RE: Paint Brush Hills Filing No. 13E
Private Detention/Stormwater Quality Pond 'D'

AS-BUILT ENGINEERING RECORD DRAWINGS

DETENTION FACILITY D
POND PLAN

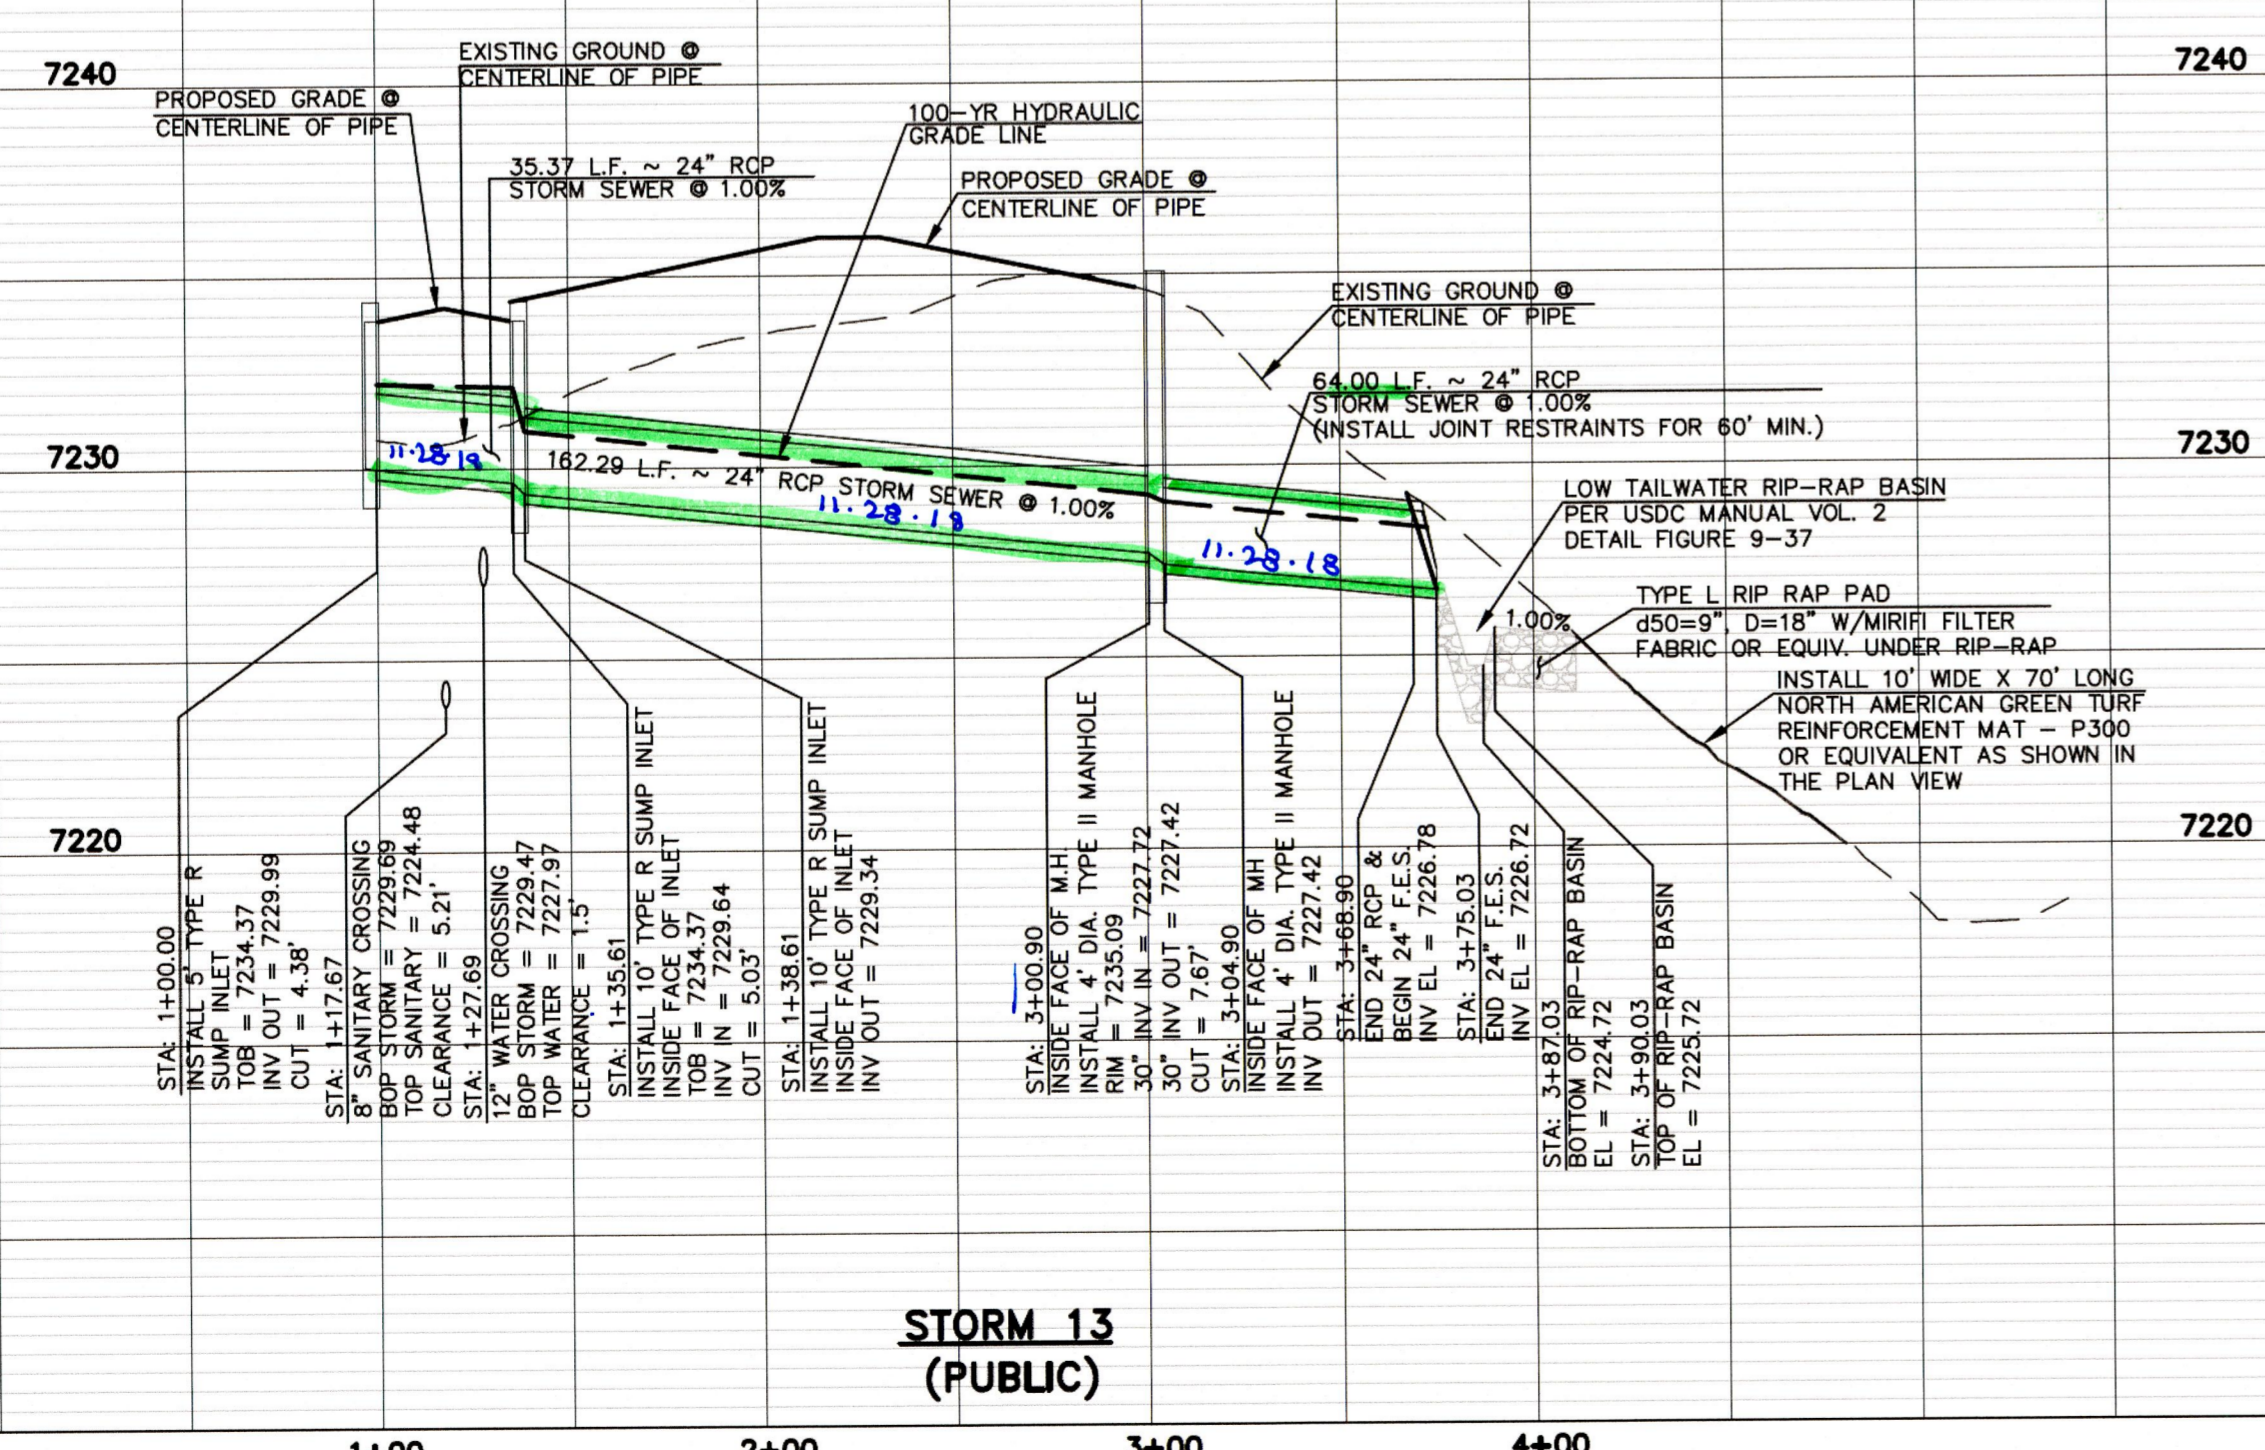
See comments on the As-builts PDF.
